# Product Change Notification

Product Group: OPT/Thu Apr 22, 2021/PCN-OPT-1179-2021-REV-0

## Redesign of IL300 Linear optocoupler product series

**Details of Changes to IL300 Series**  
**Addressed in**  
**PCN OMV-1179-2021**

<b>Package Dimension:</b> The package still conforms to the JEDEC standard, some of the dimensions have slight changes.

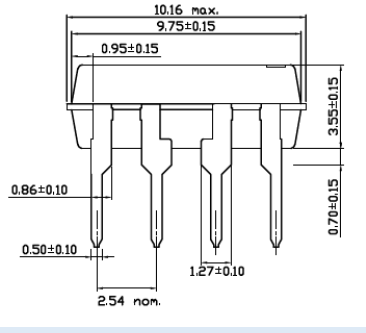
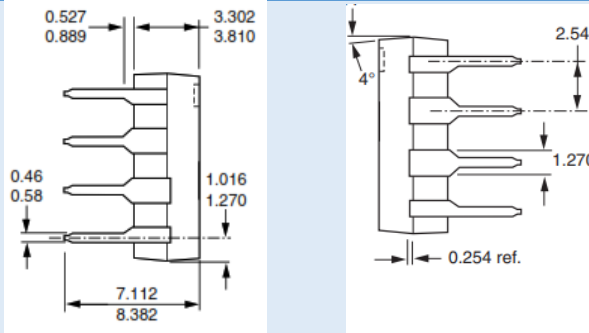
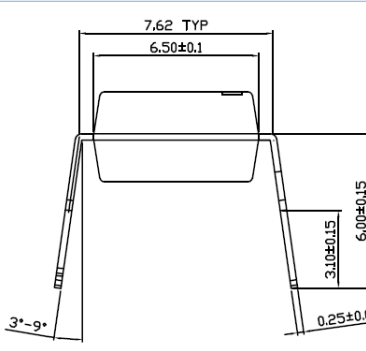
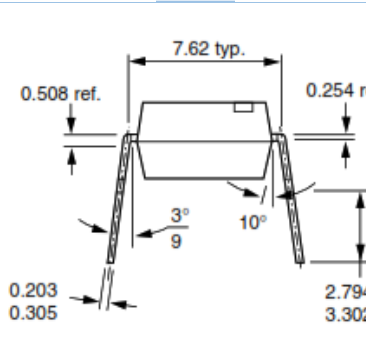
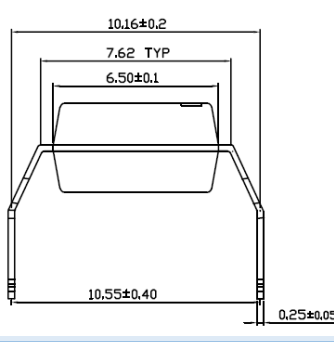
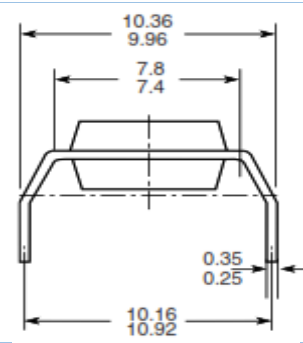
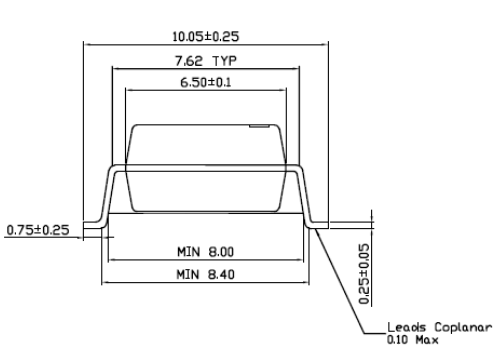
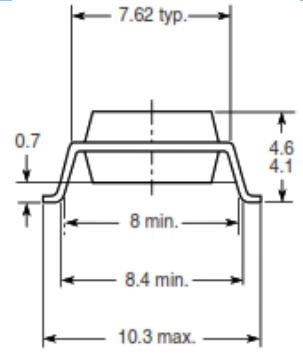
The package has been redesigned resulting in several changes. The most notable of these changes is the colour of the outer molding compound. Less noticeable is the change in construction and the change in package dimensions.

#### 3.7.1 Changes to Data Sheet limits.

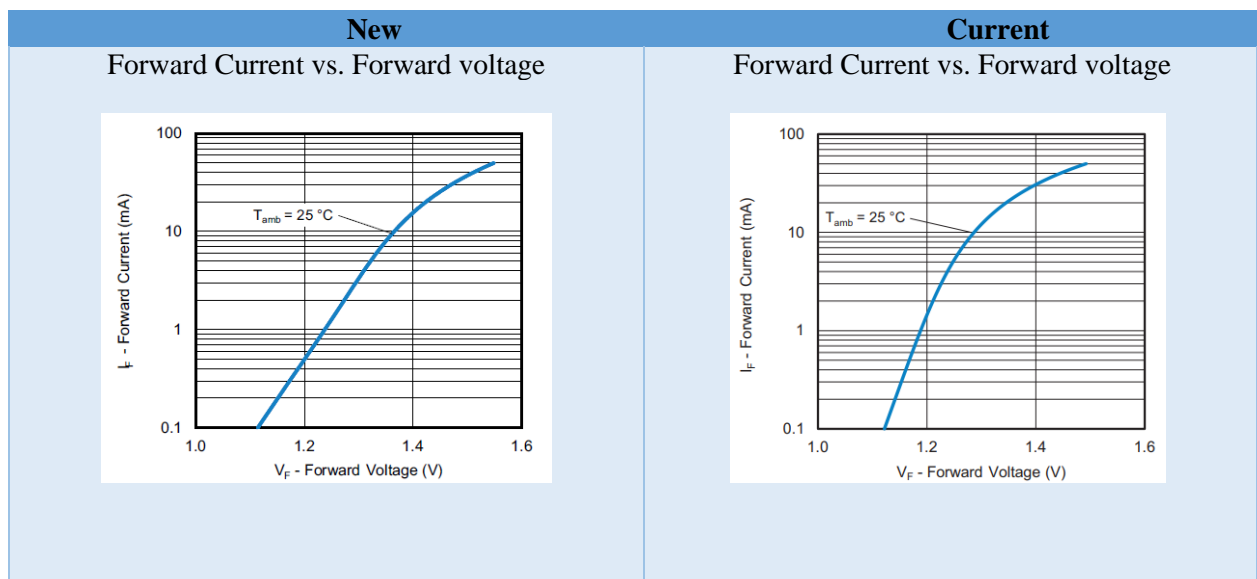
The following shows a comparison of the parametric limits that were changed in the data sheet as a result of this new design.

## 3.8 Characteristics

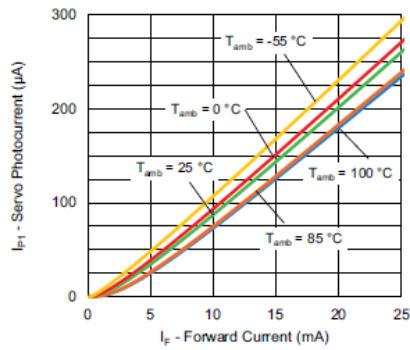
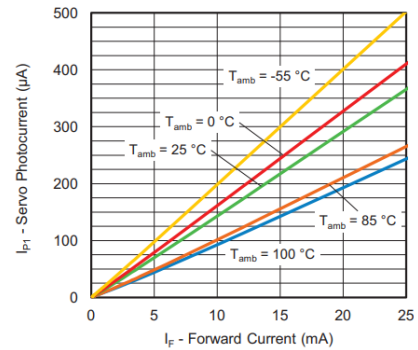
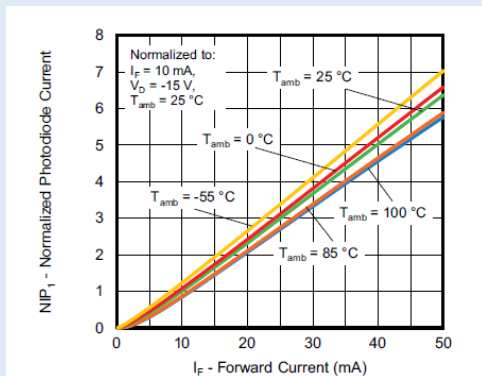
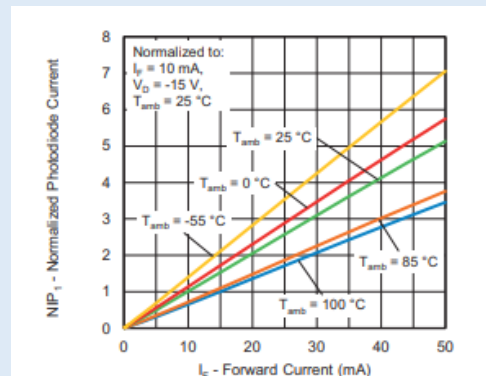
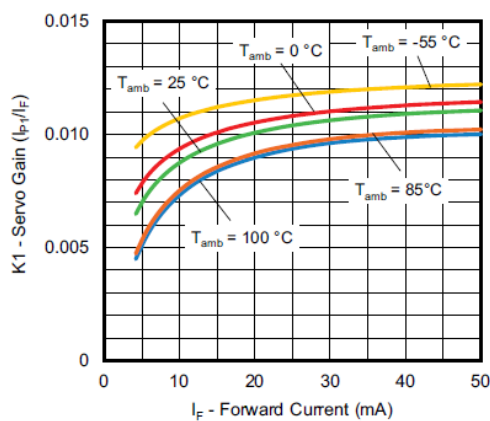
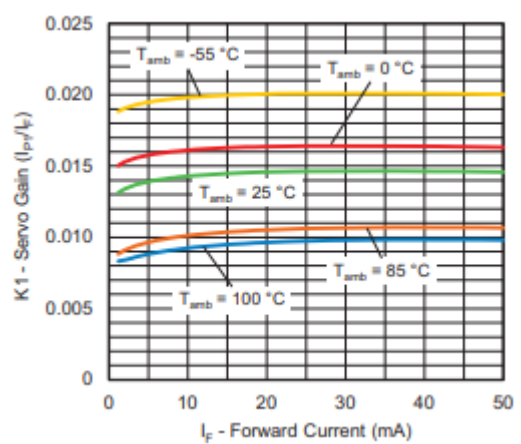
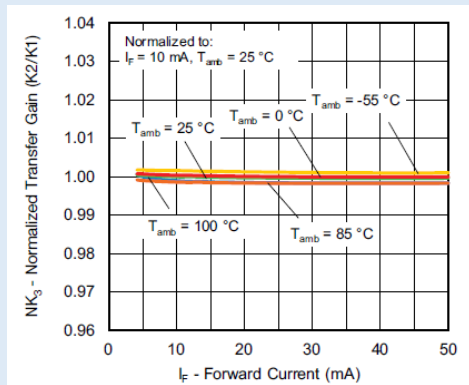
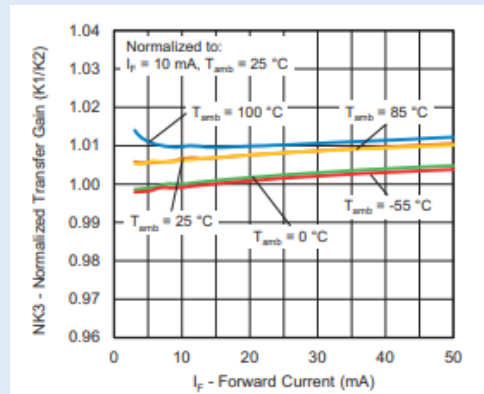
Detailed product characterization has been performed on this series of products. Some slight changes in electrical parameters and performance were observed.
